PRIMARY HEALTH CARE CENTERS
NUMBERED KE-01, KE-02,
KE-03, KE-04, AND KE-05
KIRKUK, IRAQ

SIGIR PA-06-042
SIGIR PA-06-043
SIGIR PA-06-044
SIGIR PA-06-045
SIGIR PA-06-046

SUBJECT: Report on Project Assessments of Primary Health Care Centers Numbered
KE-01, KE-02, KE-03, KE-04, and KE-05 in Kirkuk, Iraq (Report Numbers
SIGIR-PA-06-042, PA-06-043, PA-06-044, PA-06-045, and PA-06-046)

Site Photo 45. Ventilation ductwork

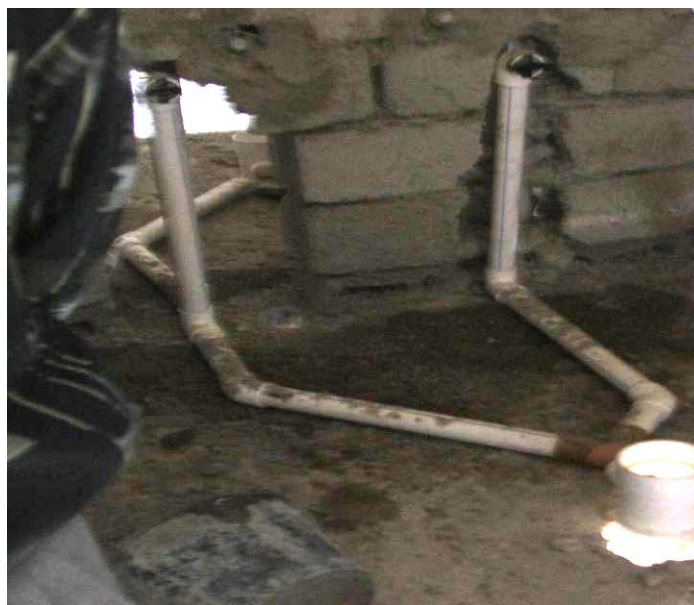
The SORS required new thermostats, heating, exhaust, ventilation and cooling systems. Work and equipment required also included condensing units, air handling units, coils, piping, ventilation and exhaust fans, grilles, registers, hangars, insulation, and fasteners. The SORS required all work to comply with IMC. The mechanical work was underway. The fabrication and construction of the ventilation ductwork was nearly complete and appeared to meet the contract requirements (Site Photo 45). We did not observe duct fittings, grilles, registers, and diffusers on site. We did not observe the heating and cooling equipment connected to either the ductwork or the equipment on site.

Site Photo 77. First floor structural beams and column

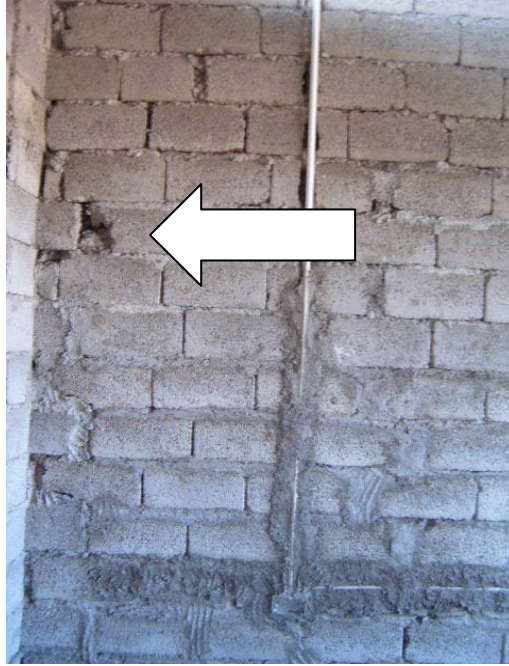
At the time of the site assessment, all reinforced concrete columns, slabs, and ceiling beams appeared complete and most of the formwork removed. For a picture of the concrete columns and remaining formwork, see Site Photos 77 and 78, respectively. The contract and design specifications required cast in-place reinforced concrete structural beams, columns, and slabs. We assessed only a fraction of the structural concrete work due to time constraints on site. The ground floor columns, ground floor structural beams, ground floor ceiling slab, interior stairwell, x-ray room walls, first floor structural beams, first floor columns, and first floor ceiling slab all appeared almost complete; however, we identified quality issues. During the site assessment, we observed work in progress on the block walls. The block walls appeared to be of substandard construction with quality problems. For instance, we observed block rows not level, walls with unfilled gaps between blocks, broken blocks, blocks improperly installed, and bricks of different sizes used in the wall construction. Site Photo 79 shows broken blocks in wall construction. We observed preparatory work in progress on the roof; however, at the time of the assessment, we did not observe roof construction activities underway (Site Photo 80).
